EA AMENDMENT APPLICATION: RESPONSE TO NPM / OTHER ISSUES BARBARA PROJECT

PREPARED FOR
AERIS RESOURCES PTY LTD

19 AUGUST 2024

Project Name:	Barbara Project
Report Title:	Addendum: EA application, response to NPM / other issues
Client:	Aeris Resources
Project Manager:	Stuart Ritchie

Figure 1: Barbara Mine, Stage 1 Long Section as at January 2027

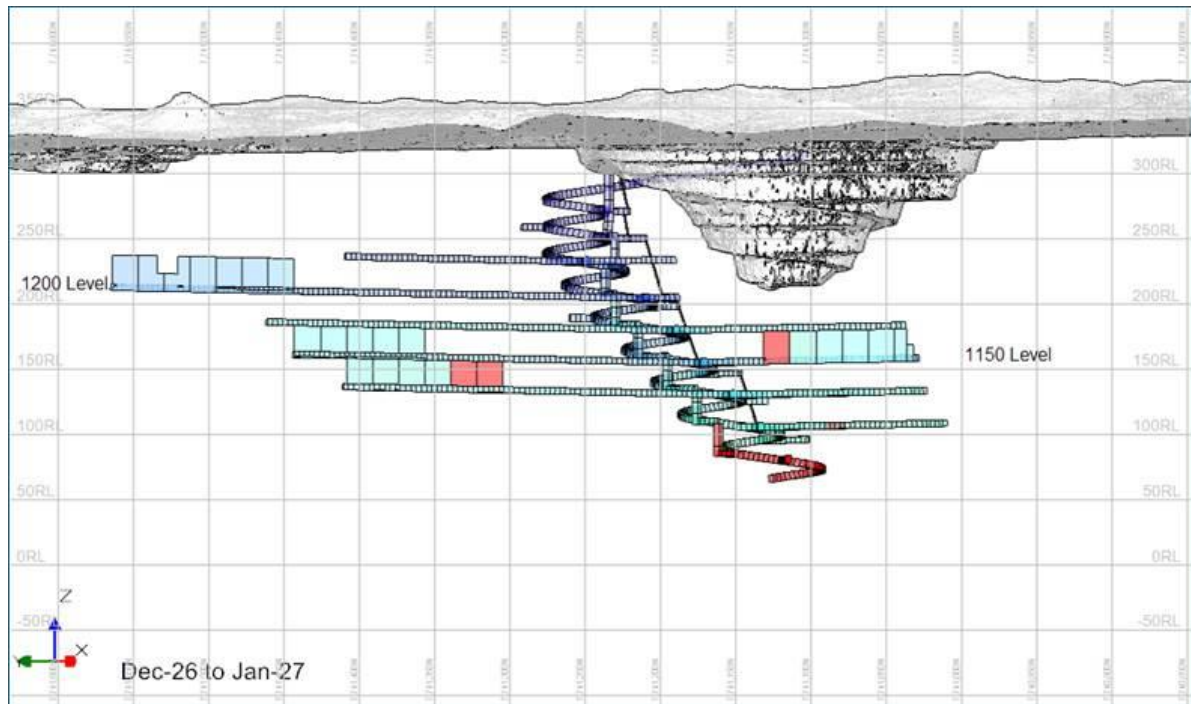
Following that submission, further correspondence was received from DESI dated 15 August 2024 identifying a number of outstanding concerns with the EA amendment application. All but one of these concerns were related to the proposed removal of the crown pillar and the proposed level of 'compression' of milestone dates.

Figure 1 illustrates Stage 1 underground mining activities, as envisaged at the end of December 2026. It indicates one year of development and one year of underground mine production. There are no material differences from the initial life of mine (LOM) proposed; it is only the first two years of mining as previously presented in the EA amendment application, and is referred to as Stage 1.

To address these concerns, Aeris has revised the proposed Project to retain the crown pillar and amend the mining dates to provide for Stage 1 of a staged underground mining approach, as detailed in Section 2 of this report.

Figure 5: South Pit storage curve (WMV Environmental 2024)

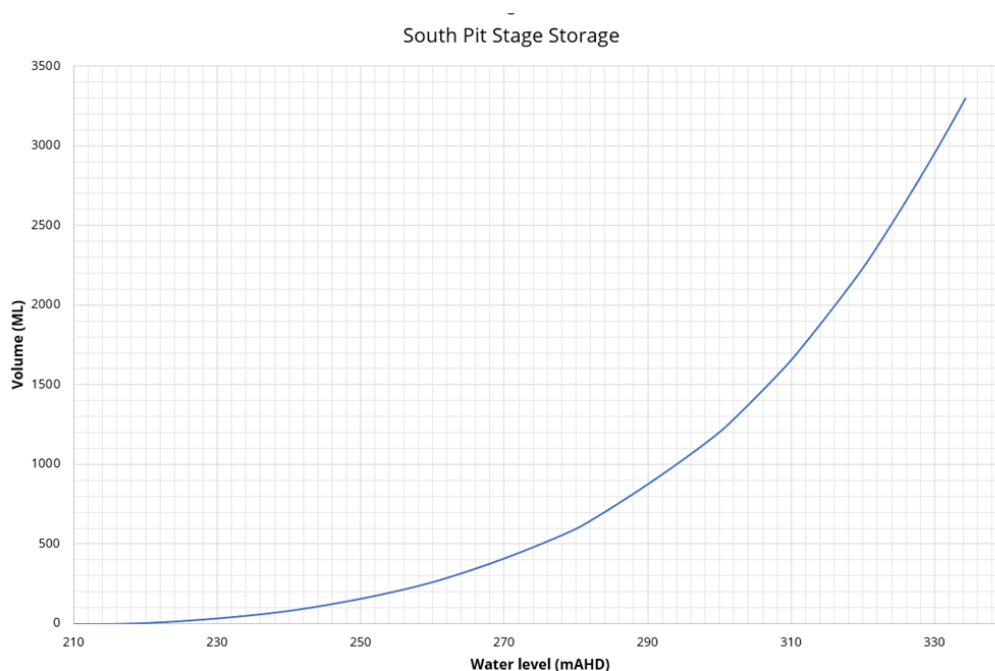
As outlined above in Section 2, the revised Project proposal, which retains the crown pillar, addresses this concern. The correspondence from DESI dated 15 August 2024 noted this issue as having been addressed via the updated 'staged approach' to the Project.

- The water demand for the Stage 1 underground development (e.g. for dust suppression is minimal and estimated to be 10 ML/month, i.e. ± 120 ML/year). Based on the South Pit storage curve (Figure 5), this volume can be sourced from the South Pit without significantly affecting the water level in the South Pit.
